LAKE HAVASU CITY, ARIZONA

ADDENDUM NO. 2
Police Department Fueling Facility
PROJECT NO.103005

Date Issued: August 12, 2022
Bid Date: August 24, 2021
To: All Planholders of Record

Attachment A
Police Department Fueling Facility
PROJECT NO.103005

PROPOSED AGST SITE PLAN

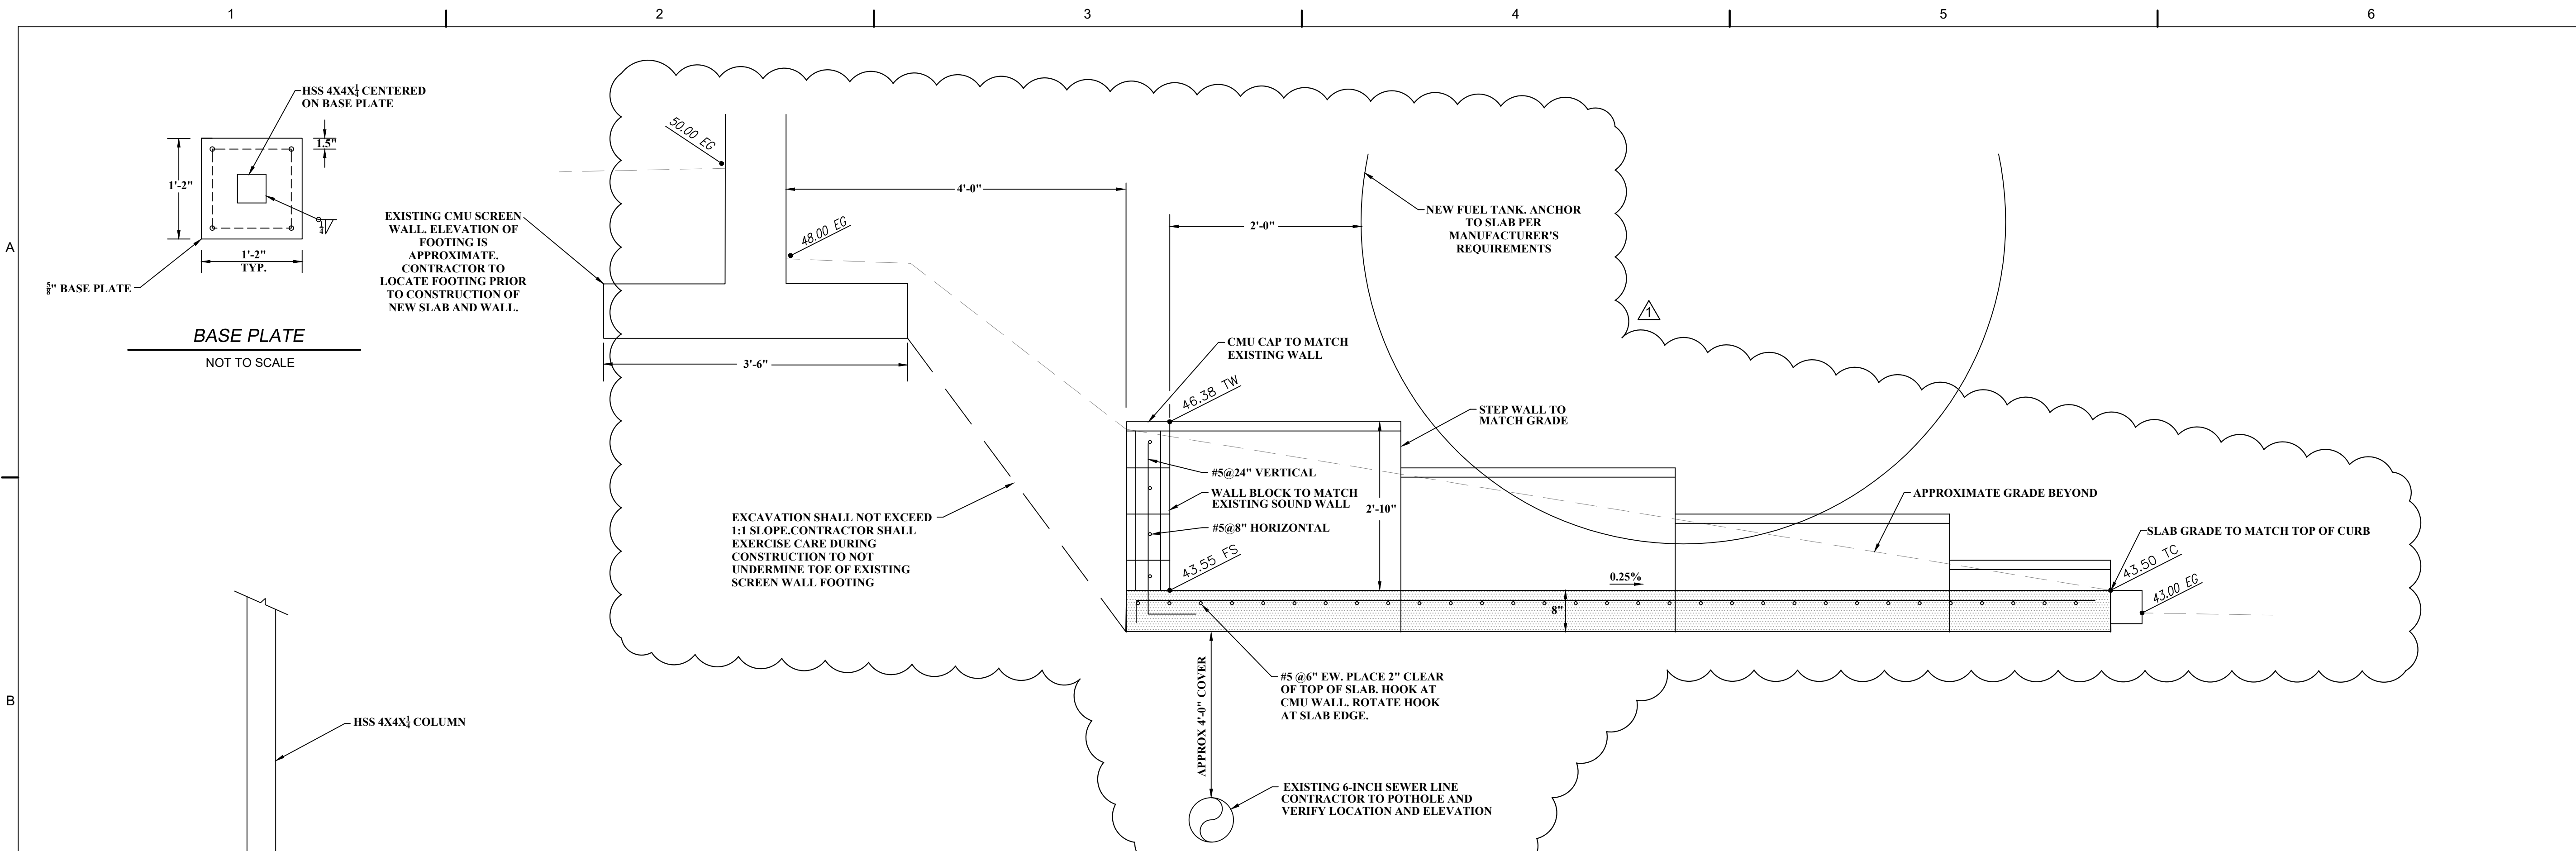
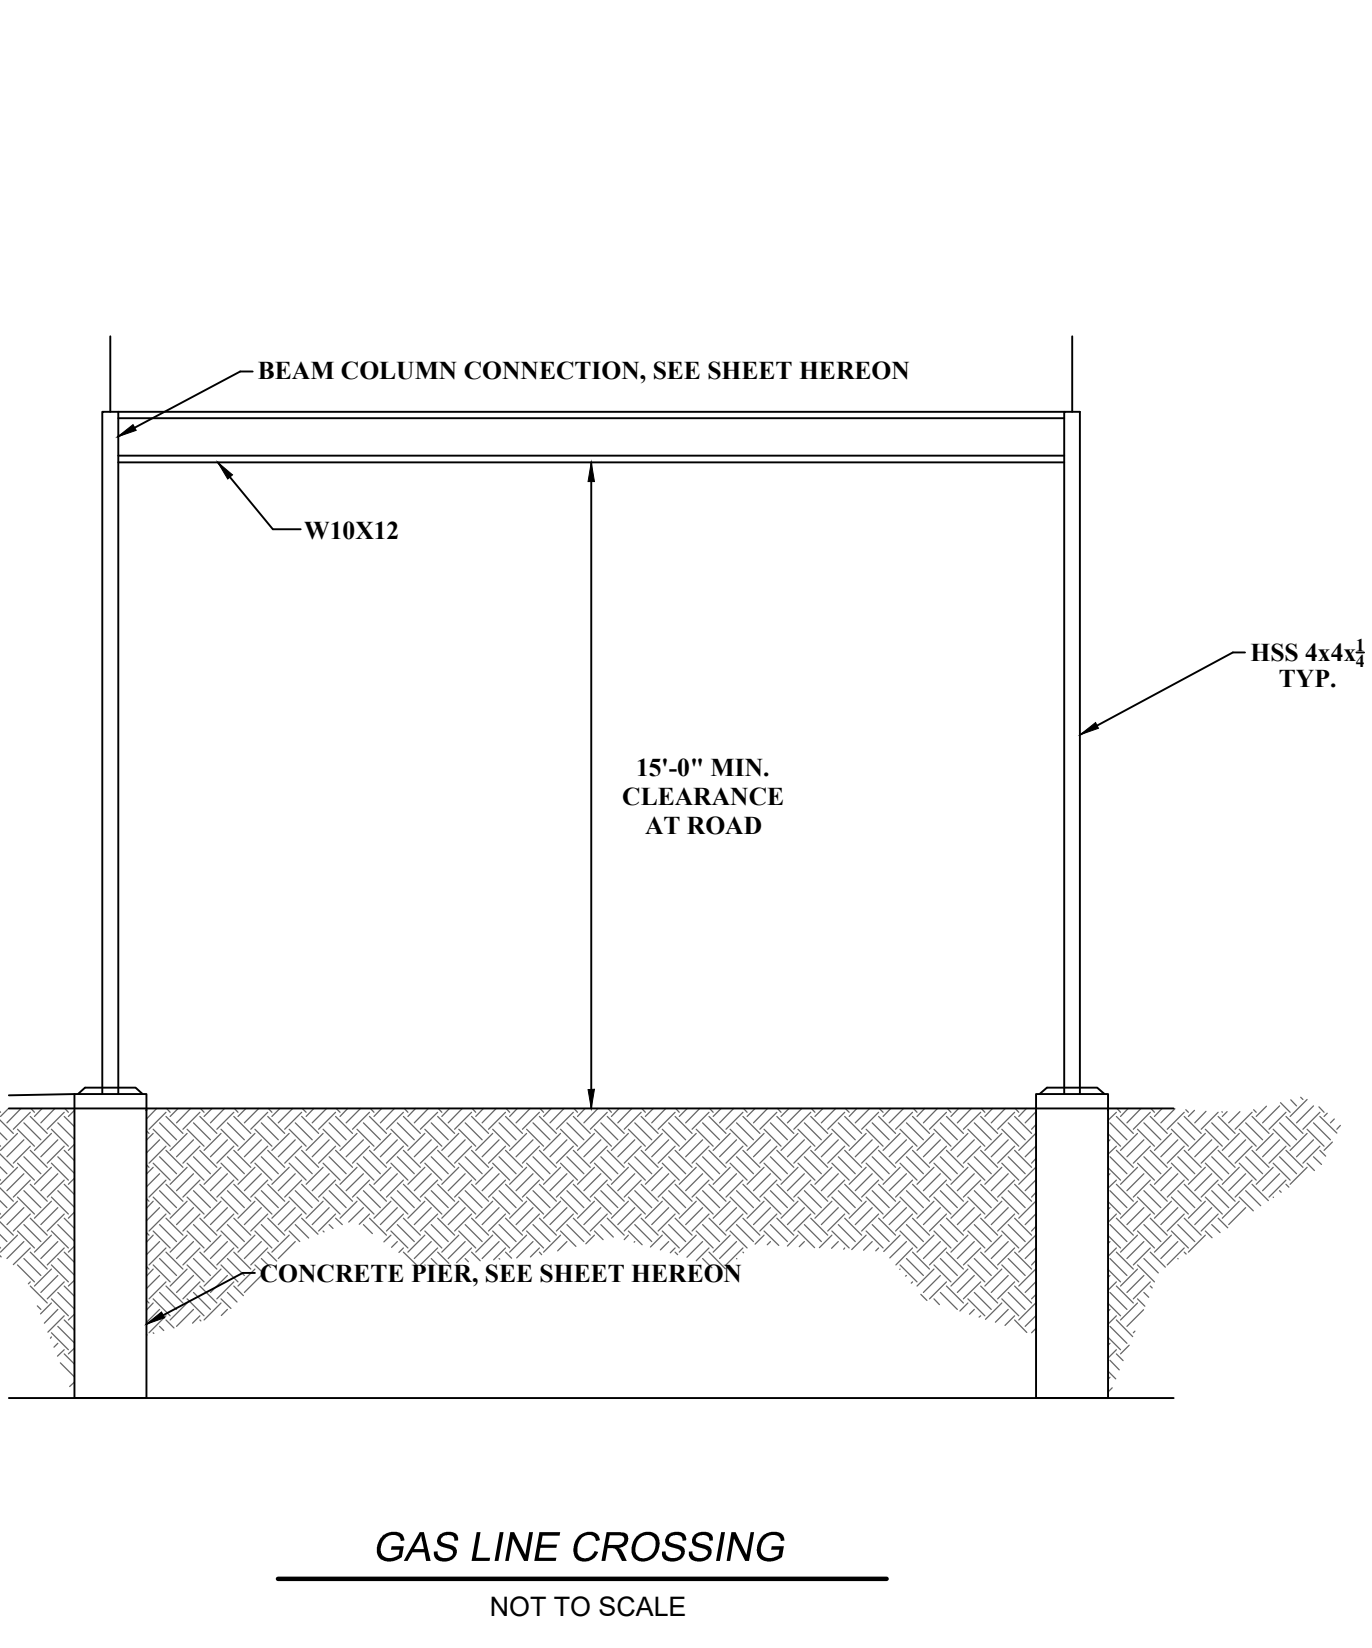
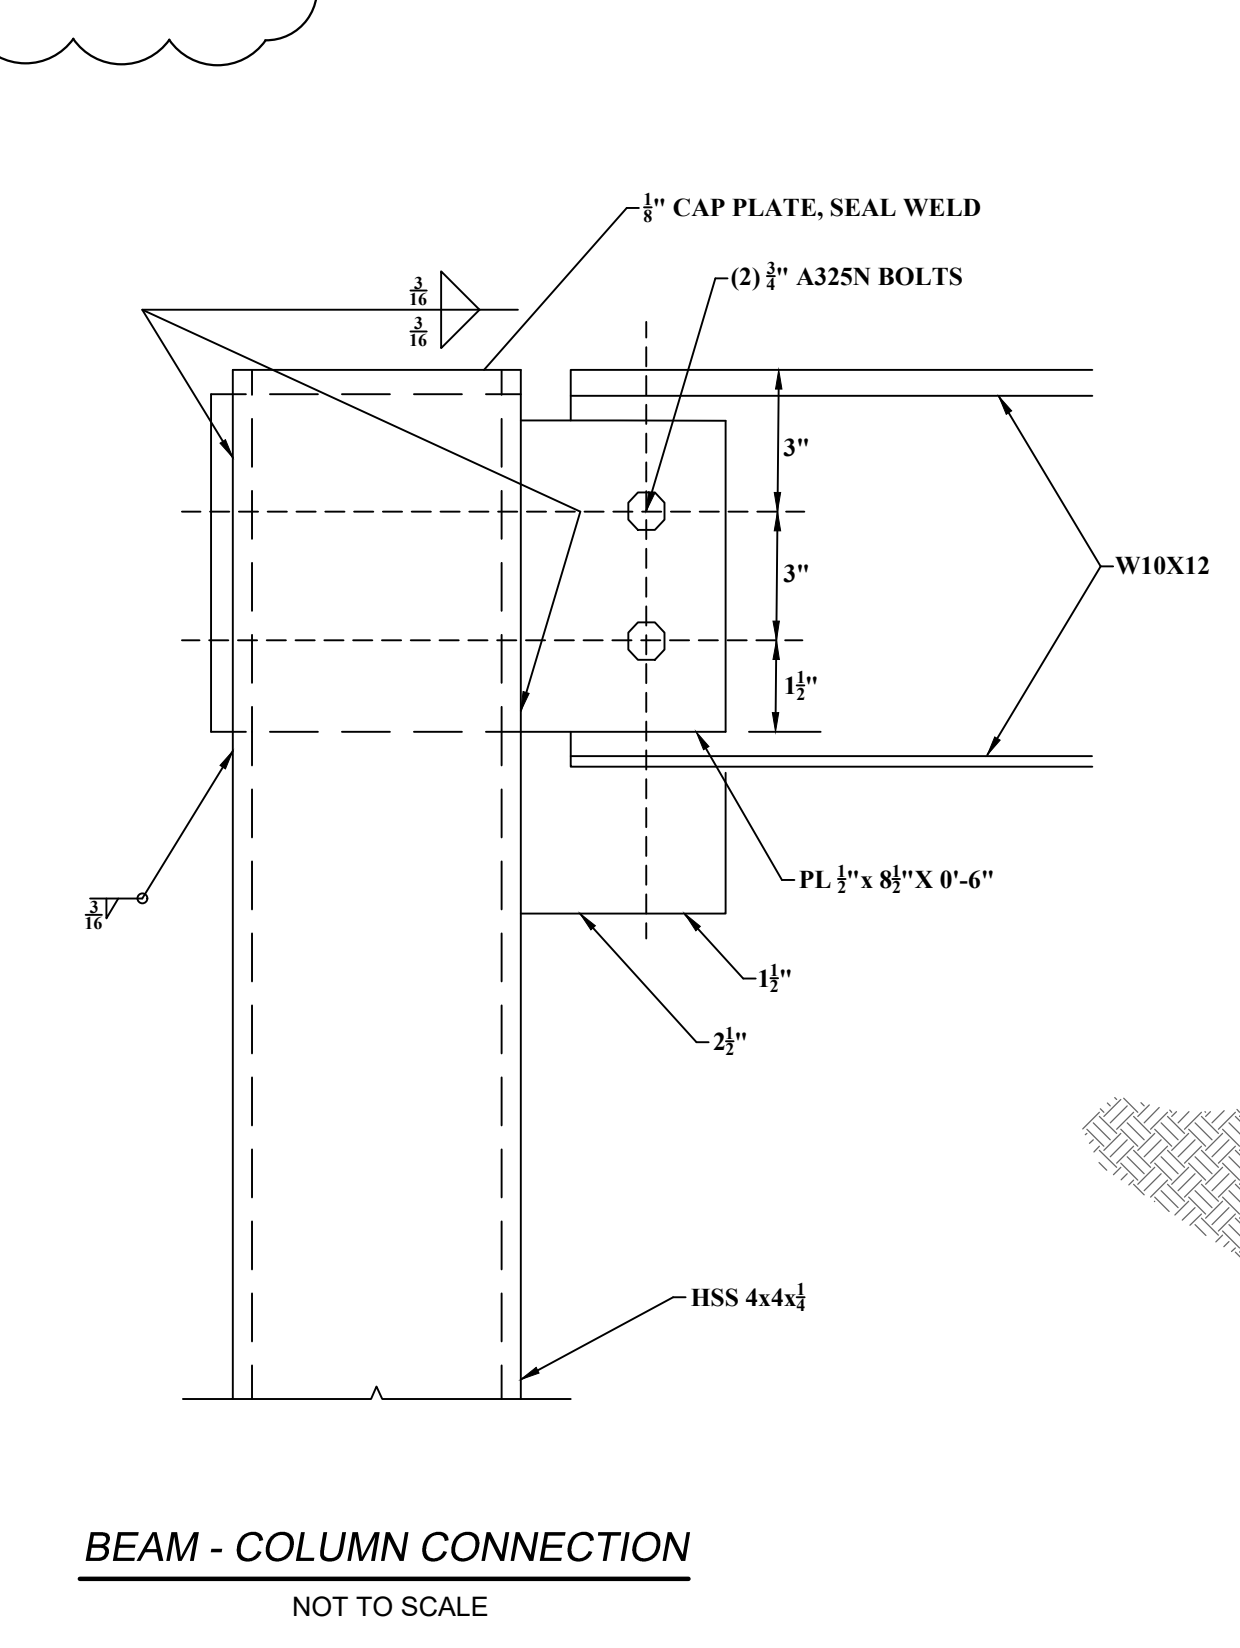
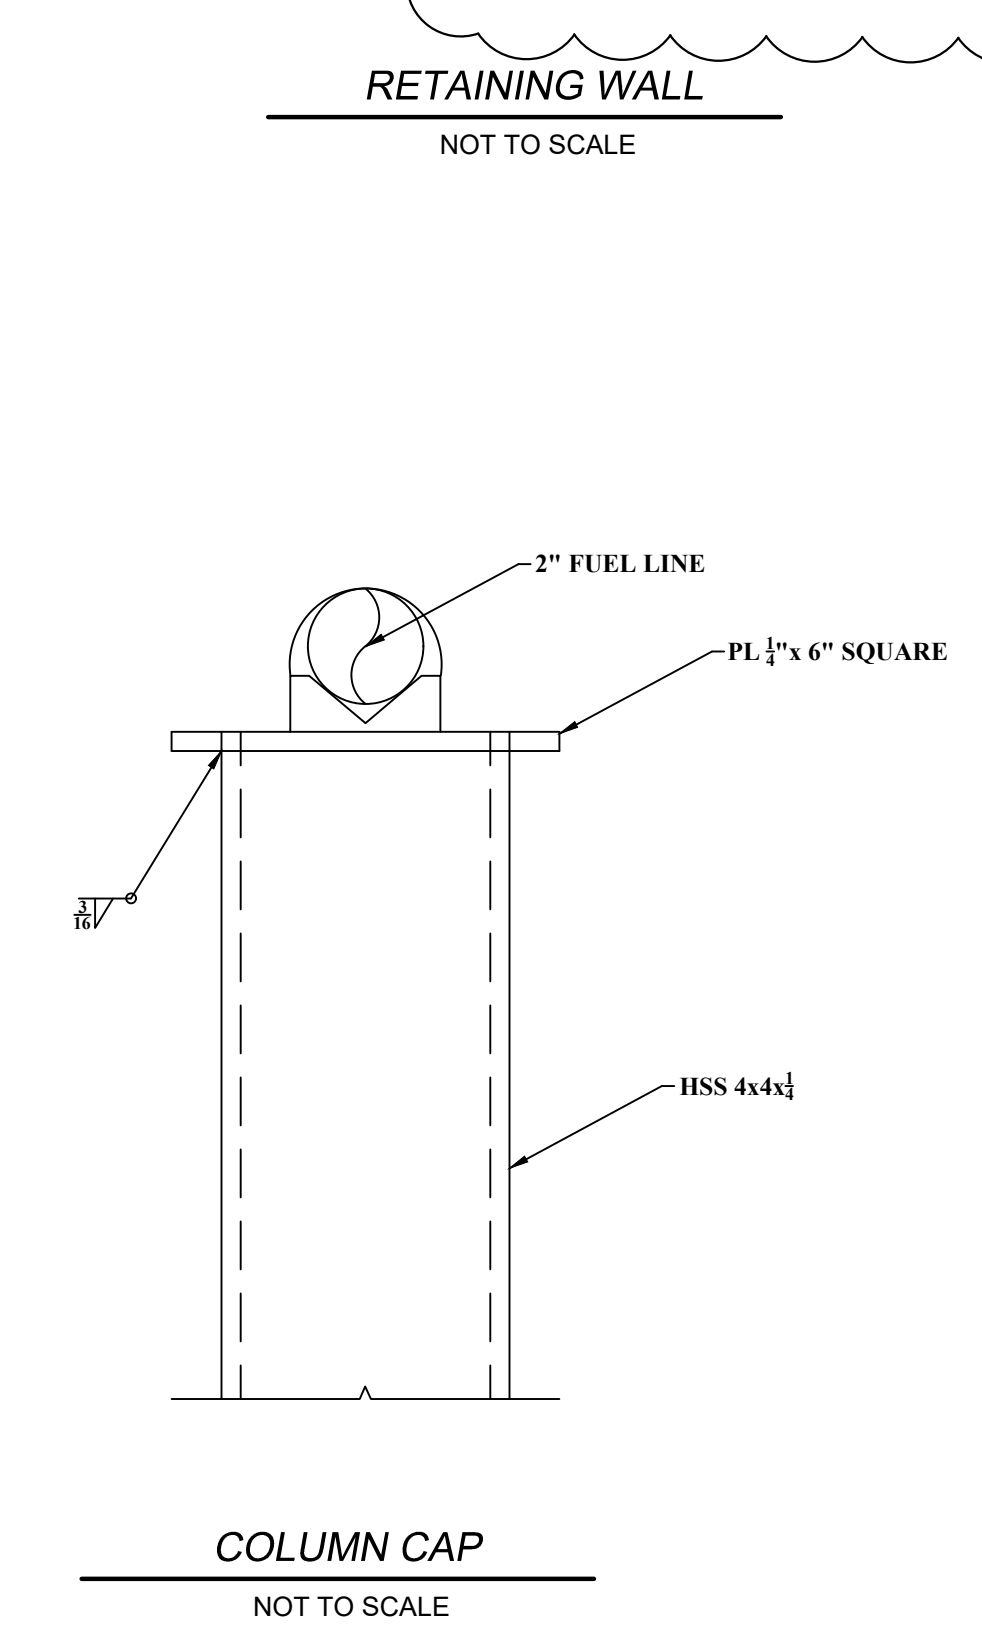
Item 3: Drawings C-2, C-3, and C-4 have been revised to:

1. Show an existing sewer line below the work area. Contractor to pothole and verify location and depth of the sewer line and the cleanout adjacent to the work area.
2. Better approximate the relative locations and slope of the existing sound wall and proposed retaining wall and tank slab.

DRAWING C-2 & C-3

Question 4: Please provide elevations for the new retaining wall slab and existing grade. Without this information we are unable to determine the amount of excavation required for the new fuel tank area and structure. This will also help determine the construction requirements for not undermining the toe of the existing screen wall footing as shown in the retaining wall detail.

Question 31: On sheet 3 there is a column called out with a base plate next to the fuel tank that is to be mounted to the slab. Currently the slab is called out to be 8" thick, and all the other columns have pier footings that are min 6' deep. Is the slab to be thickened at this one column or will a pier footing be required at this location?

Answer: Elevations were added to Drawings C-3 and C-4. Existing elevations were obtained from as-built drawings provided with this Addendum.

Answer: Neither thickening nor pier is required at the slab to withstand overturning moment.
